SERVICE BULLETIN 154 — MANDATORY

SUBJECT: Gear warning buzzer (P/N 210-0677-001)

APPLICABILITY: Version 2 Glasair IIIs (i.e., Kit #3296 and higher); earlier Glasair IIIs with the Emergency Gear Extension Retrofit Kit (P/N 353-5800-502) installed; and any Glasair I RG, II RG, II-S RG or Super II RG that has been modified by replacement of the standard PC board with the current Glasair III diode board

Figure 1: Worst-Case Buzzer Polarity (Case Always Hot)

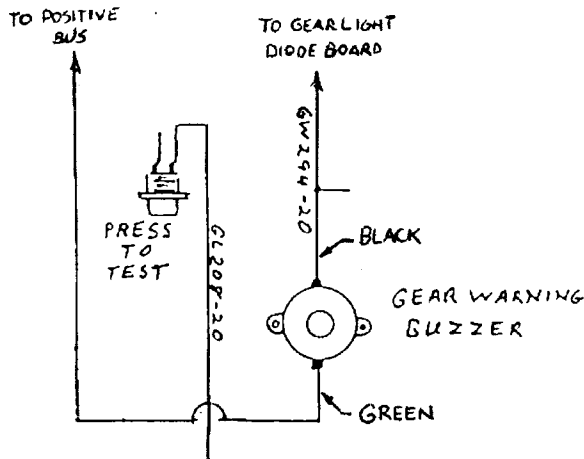
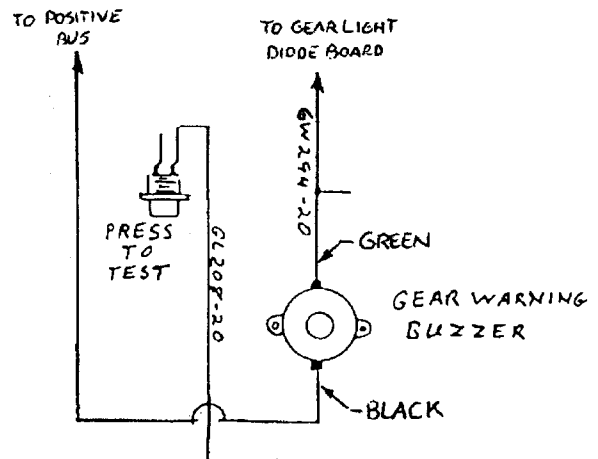
DISCUSSION: A potential hazard associated with the landing gear warning buzzer has come to our attention. If wired according to our instructions, the outer case of the buzzer will, at least sometimes, be electrically “hot,” thus posing a potential fire hazard if it should be inadvertently grounded through contact with baggage or some other metal component of the aircraft. Whether the buzzer case is always hot or only sometimes hot depends on how it is wired, but in either instance, precautions must be taken to ensure that the case cannot be inadvertently grounded.

The gear warning buzzer has two colored wires—a green and a black. However, the instructions for wiring the buzzer (whether contained in the Final Assembly section of the *Glasair III Instruction Manual, Version 2* or in the Glasair III Emergency Gear Extension System Instructions (P/N 633-0195-016)) do not specify these colors. If the buzzer is wired as shown in Figure 1 on the following page, then the green wire, which is connected directly to the case of the buzzer, goes to the positive bus, and the case will be continuously energized as long as the master switch is on. If the buzzer is wired as shown in Figure 2, then the black wire goes to the positive bus, and the case will be hot only when the buzzer is activated by the closing of either the push-to-test switch or the gear warning microswitch on the flap control mechanism.

Also, inspect the buzzer to determine whether it is wired according to Figure 1 or Figure 2 above. If it is wired according to Figure 1 so that the green wire goes to the positive bus and the case is continuously hot, rewire it according to Figure 2.

Figure 2: Best-Case Buzzer Polarity (Case Hot Only When Buzzer Is Activated)
